**RE: Antelope Creek (Kings Point North) initial Submission Review Response to Comments  
CN#: 2022-6050-00; 2022-3081-00**

# KINGS POINT NORTH ANTELOPE CREEK INFRASTRUCTURE SITE PLAN

**KINGS POINT NORTH**  
AURORA, CO  
**ANTELOPE CREEK INFRASTRUCTURE SITE PLAN**  
TYPICAL TRAIL CROSS-SECTIONS

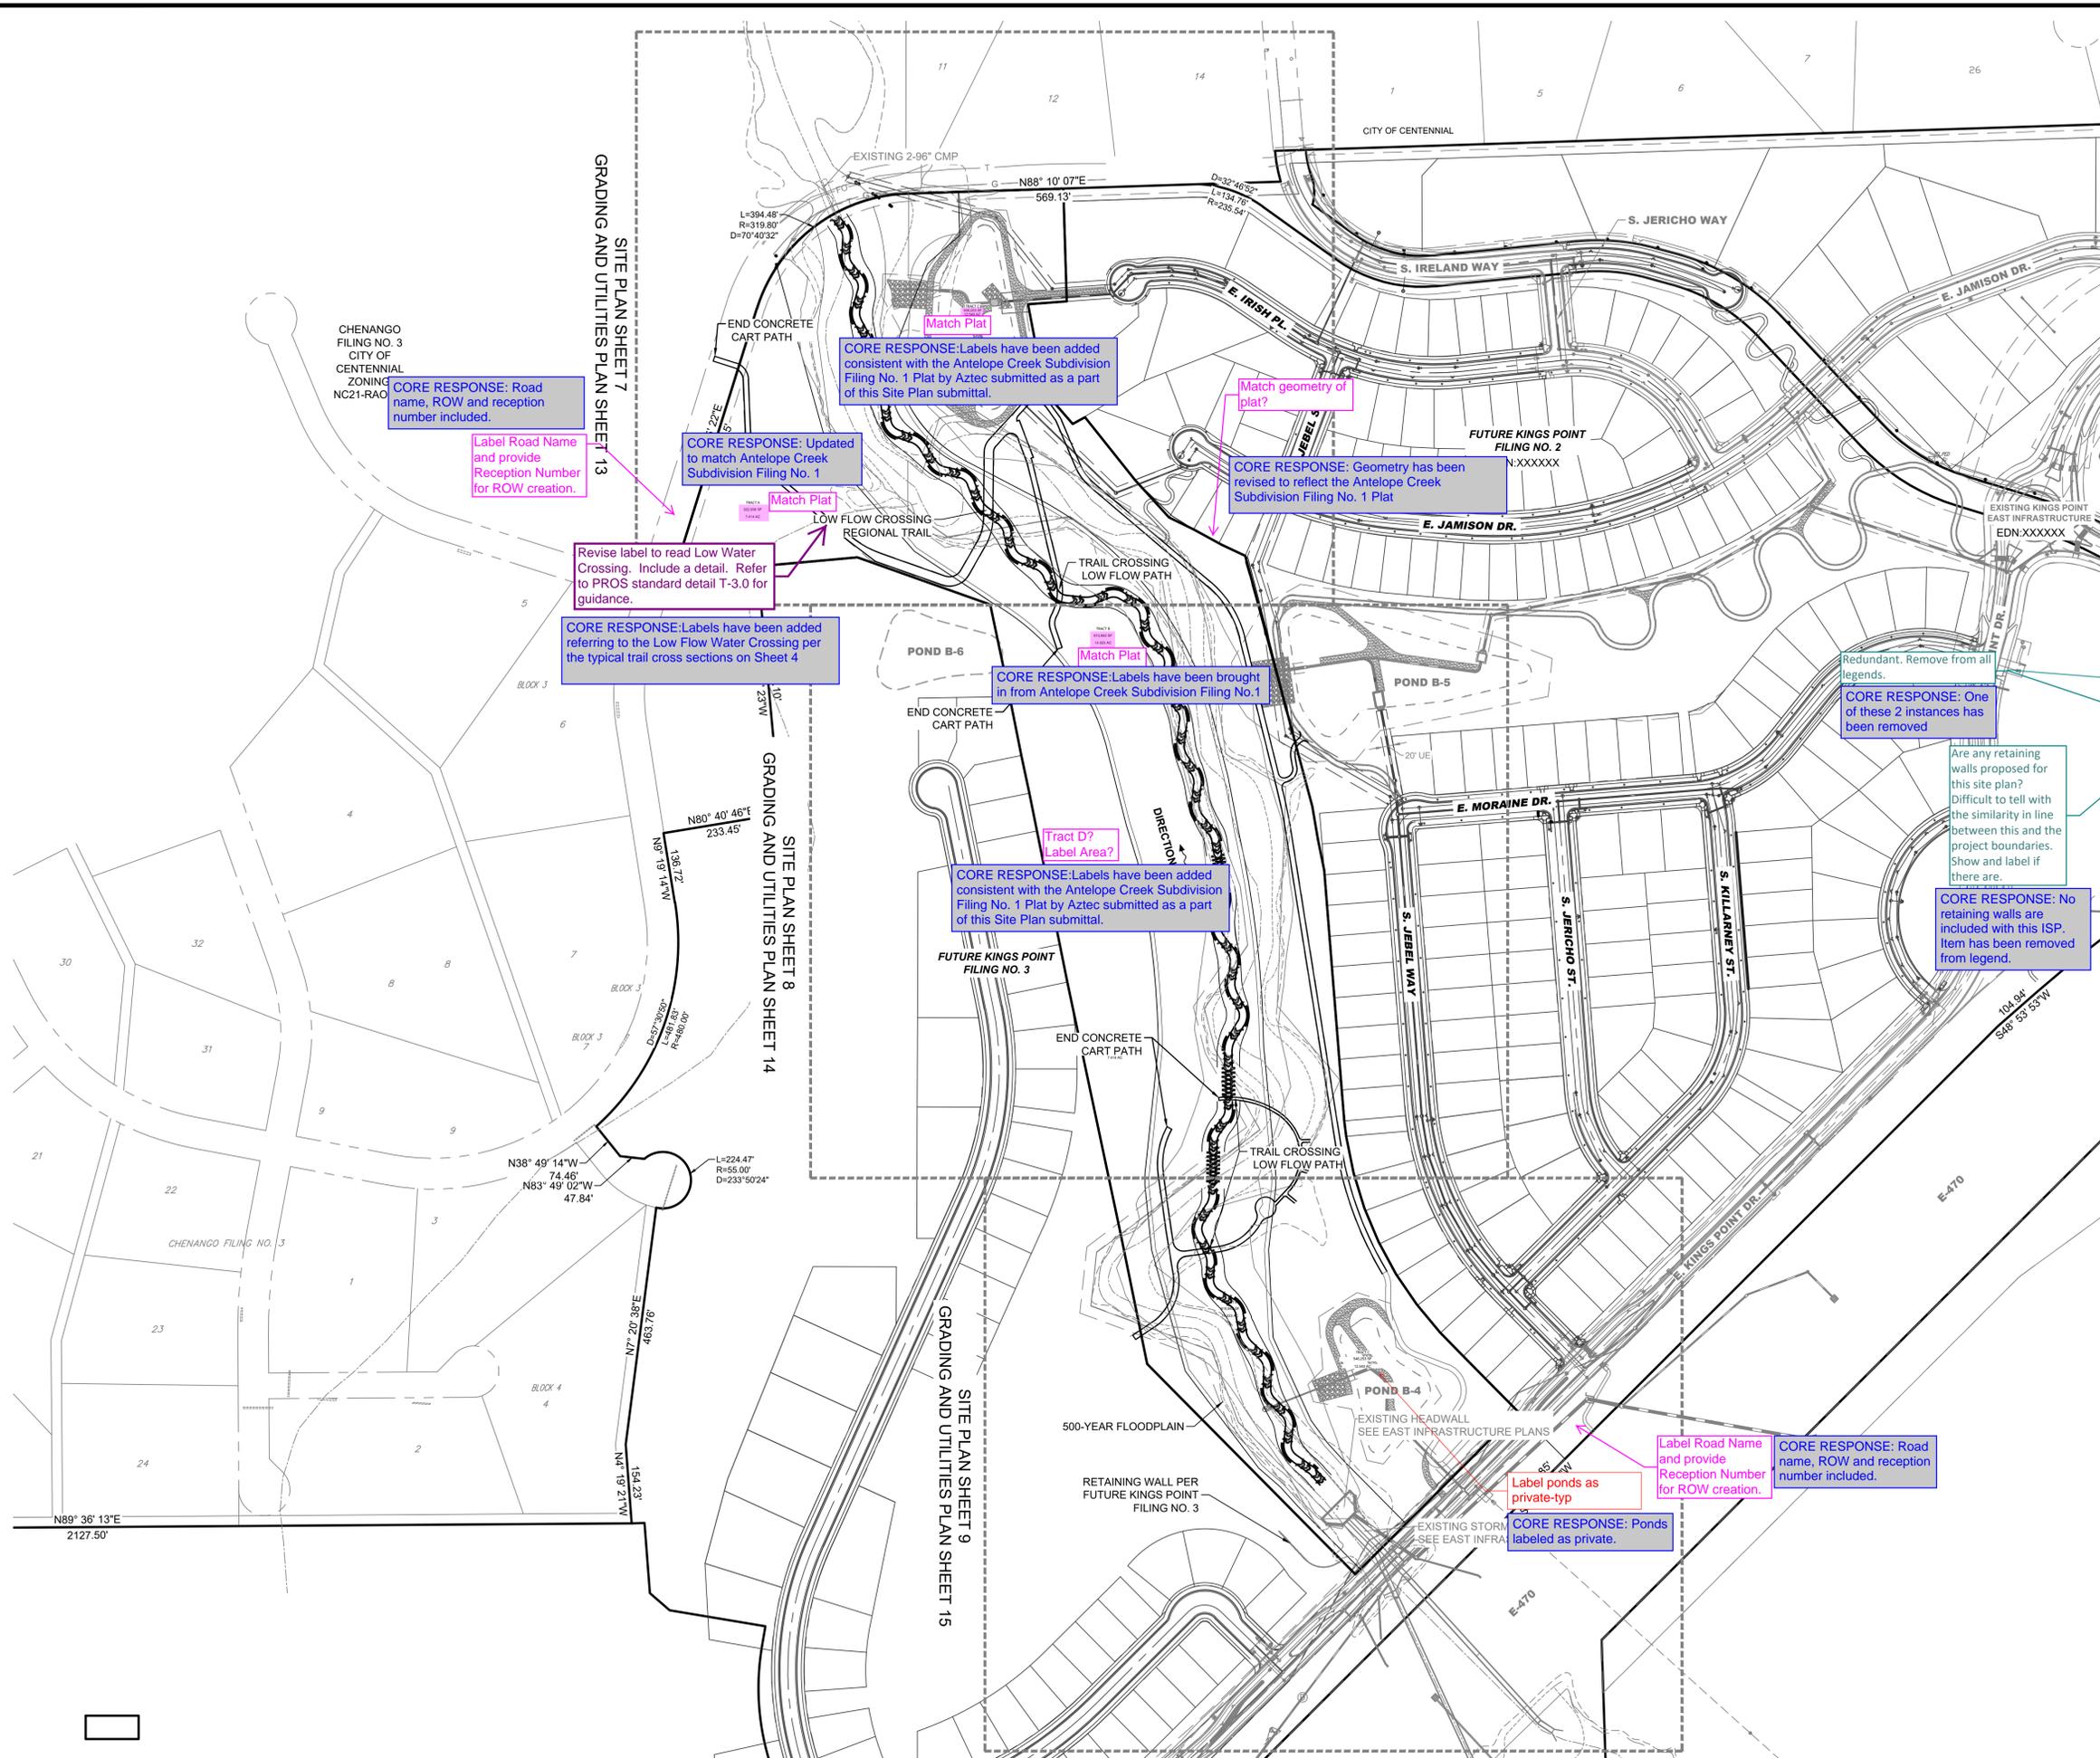
PLACEHOLDER FOR TRAIL CROSS SECTIONS

CORE RESPONSE: Typical trail cross sections have been added to Sheet 4 of the revised set.

Add the note about the landscaping for Tract B to be installed with the Golf Course  
 RESPONSE: NOTE ADDED.

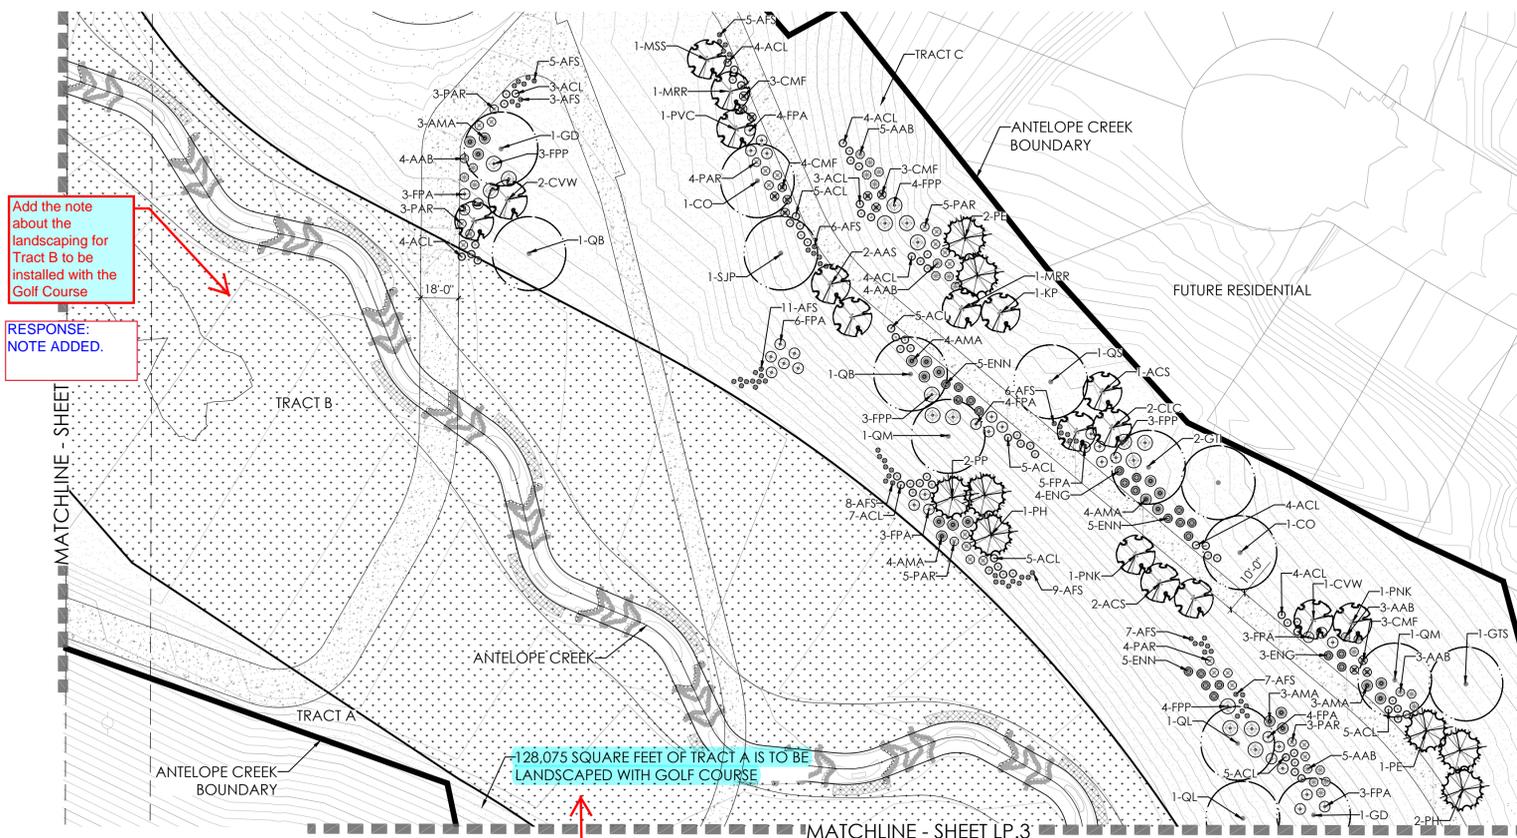
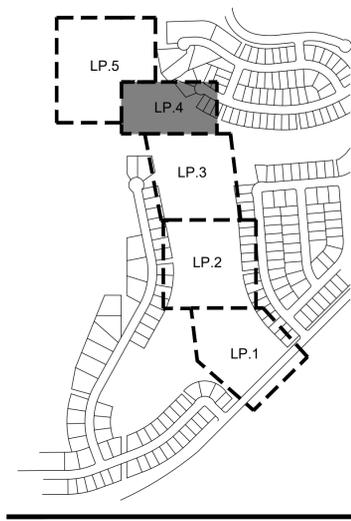
128,075 SQUARE FEET OF TRACT A IS TO BE LANDSCAPED WITH GOLF COURSE  
 According to the plat, the arrow is technically pointing to Tract D  
 RESPONSE: NOTE ADJUSTED.

-  OPEN SPACE
-  OPEN SPACE (FLOODPLAIN)

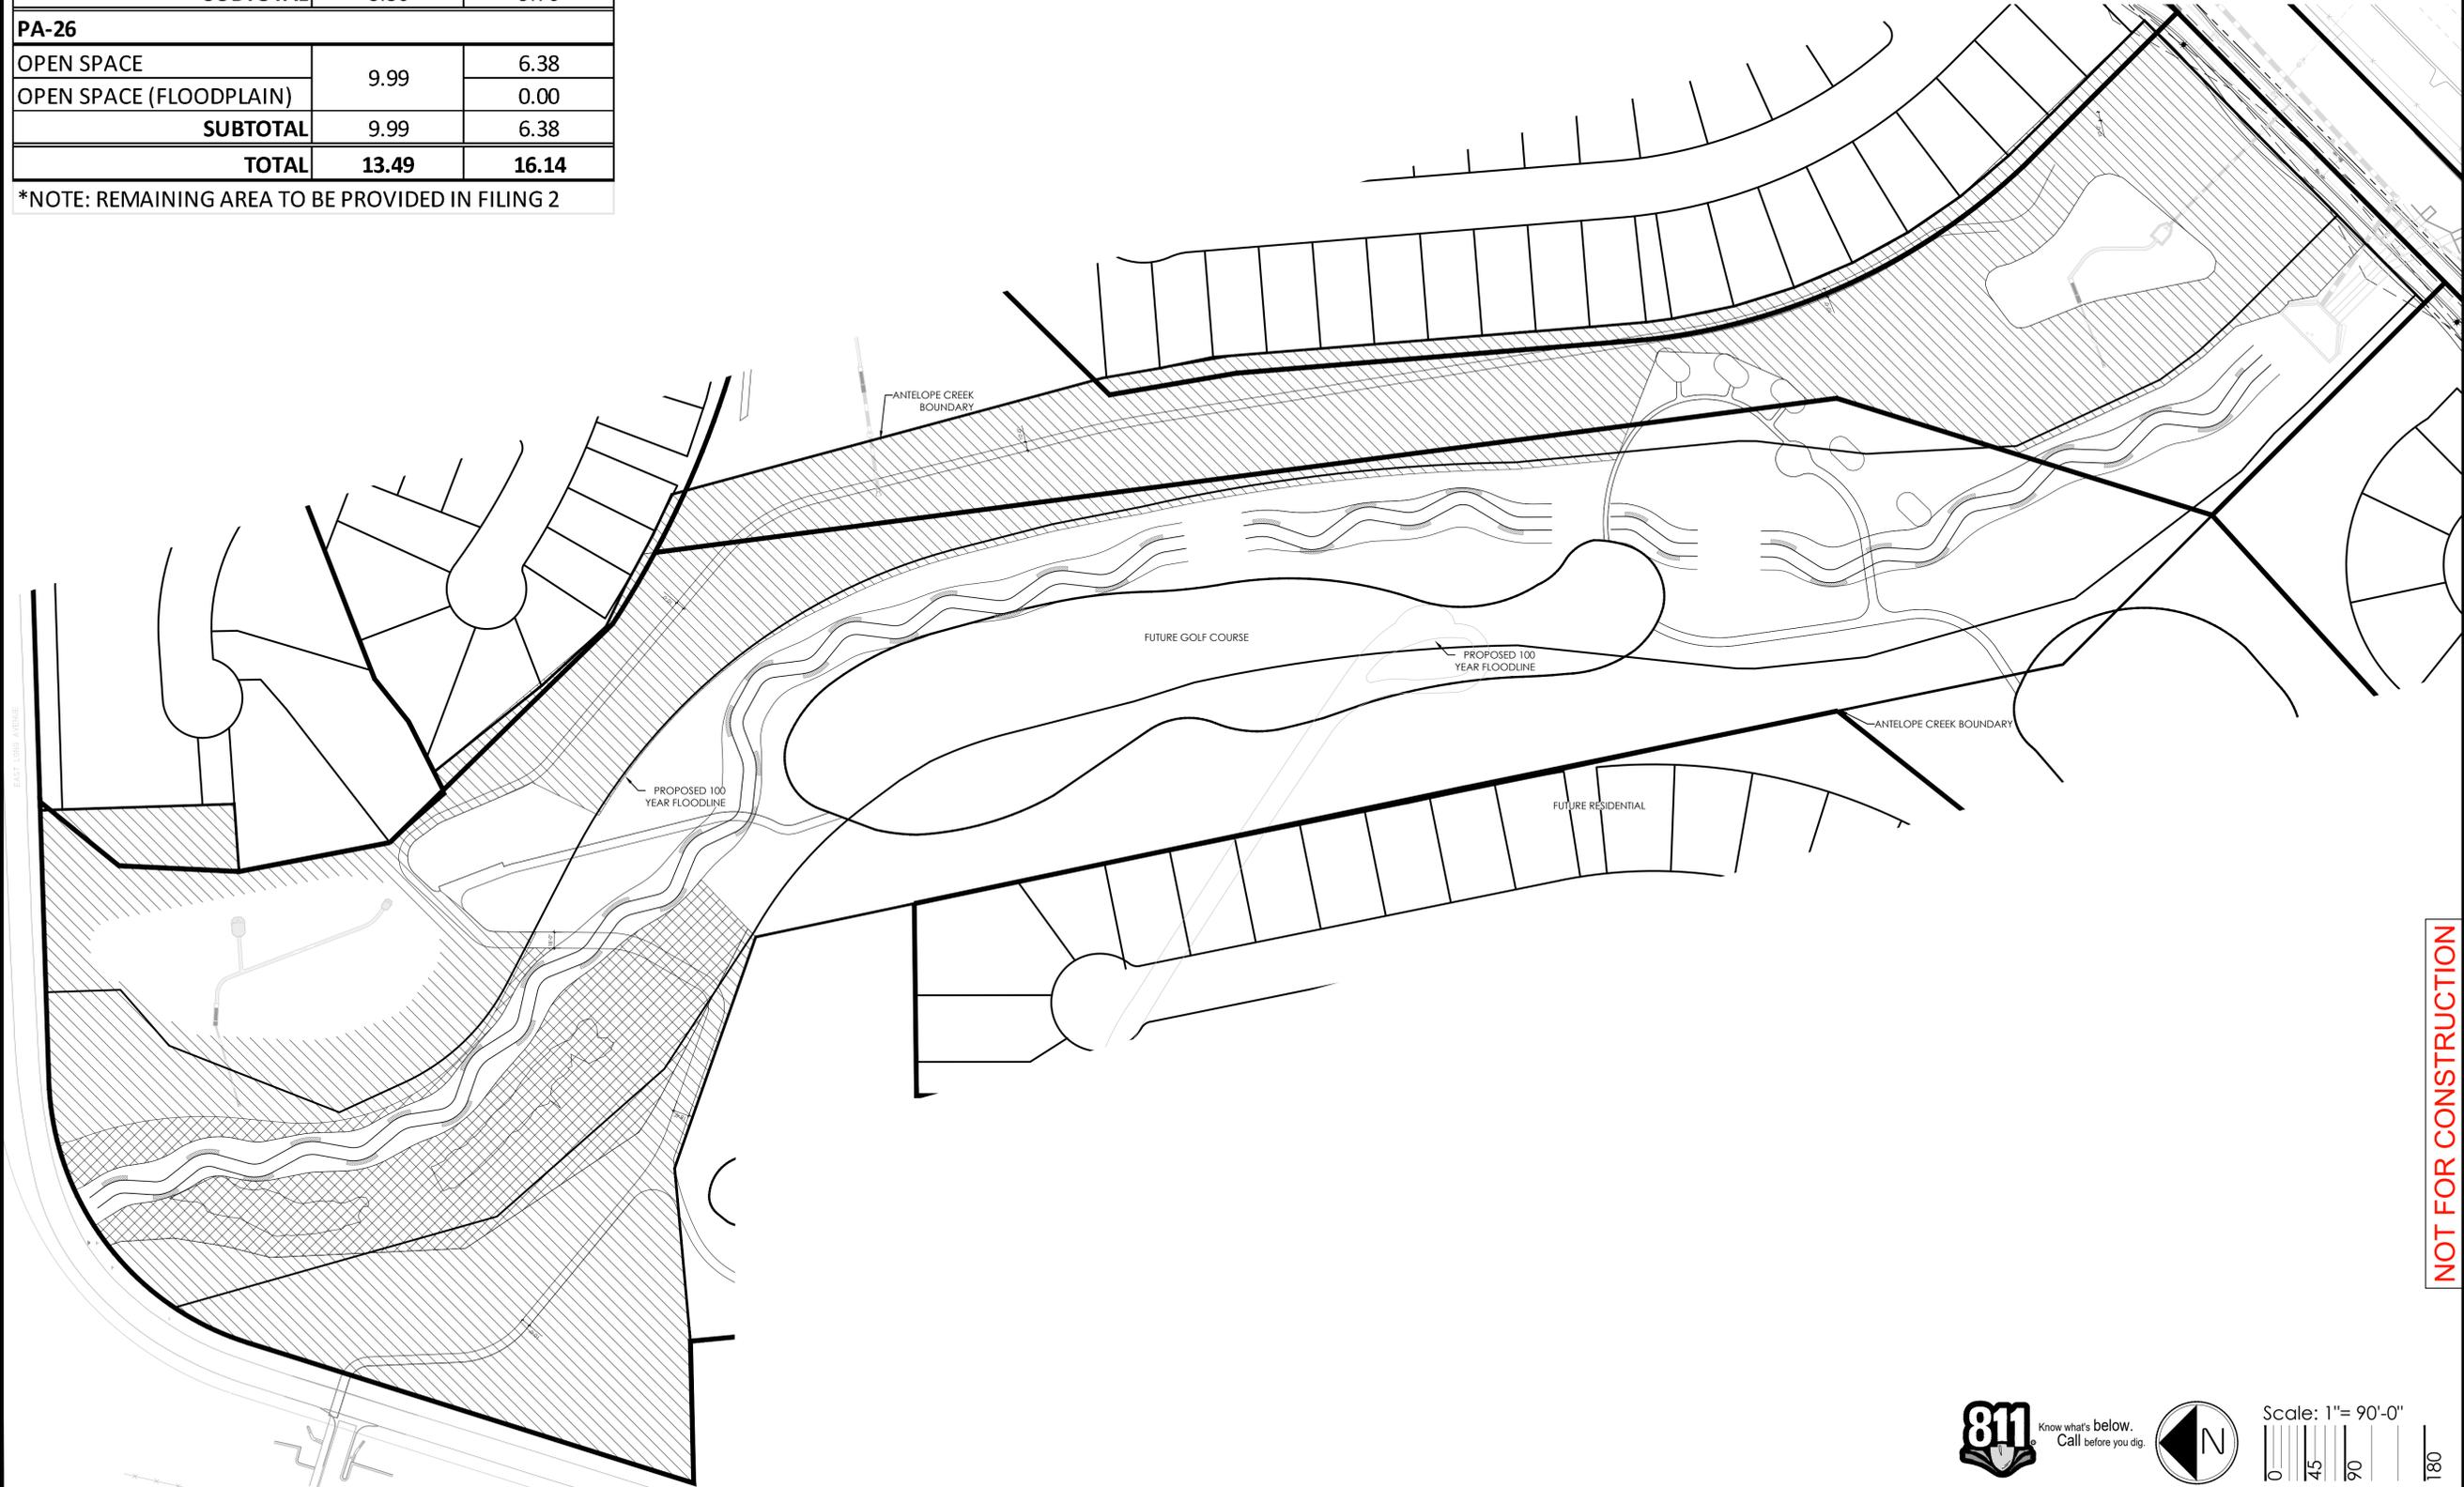
- n. The linework taken from this plat should serve as a base map to create an exhibit for inclusion as part of the Site Plan. The exhibit should delineate the areas within Tracts A, B and C (?) which are intended to satisfy the amount of land dedication to be dedicated as per the Master Plan. Calculate the acreage of open space dedication so as to meet or exceed what is outlined in Form J (13.49 ac. total).

**RESPONSE: Overall open space plan has been added, can be found on sheet OS.1**
